TOWN OF ACTON
HISTORIC DISTRICT COMMISSION
472 Main Street, Acton, MA 01720

This is a request for an amendment to Application #0911, for restoration of 14 Newtown Road, Acton. Specific placement of elements on the visible facades is determined and approval is requested.

Amendment to HDC Application #0911, for restoration of 14 Newtown Road, Acton

Figure 1: Rendering of proposed North Façade

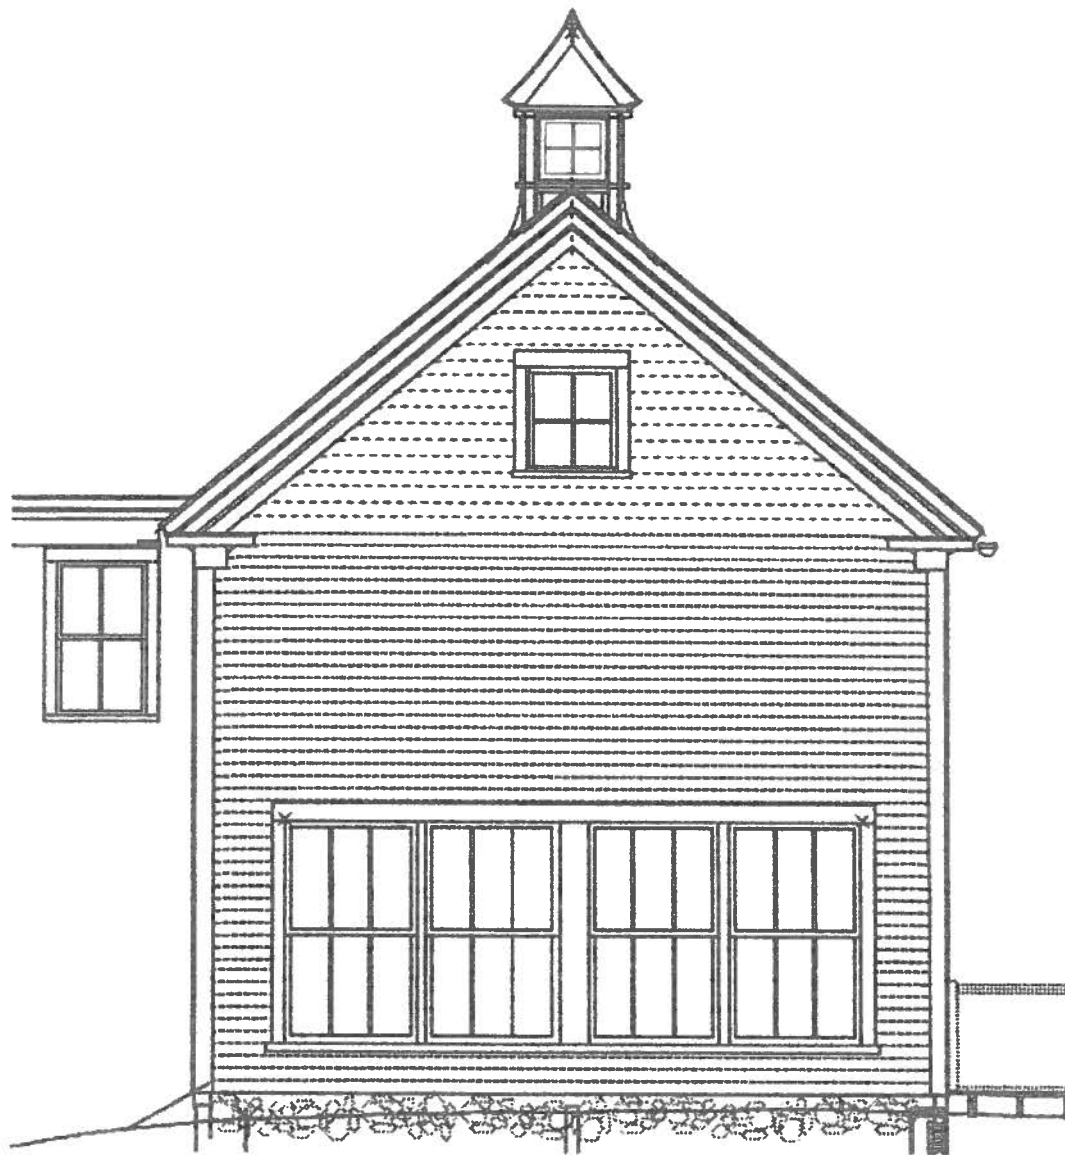
On the North Façade:

1. Replacement of the curved-header decorative 'barn doors' with a single rectangular door with a chevron pattern wood face; hardware to be selected later and presented for a subsequent amendment
2. Replacement of the originally approved panel Entrance door with a vertical-wood-slat door; hardware to be selected later and presented for a subsequent amendment
3. Placement of the second-floor windows to obey the timberframe structure constraints
4. Installation of gutter with downspouts; a 5" half-round seamed gutter with a minimum number of joints will be used.
5. Refinement of the cornice details
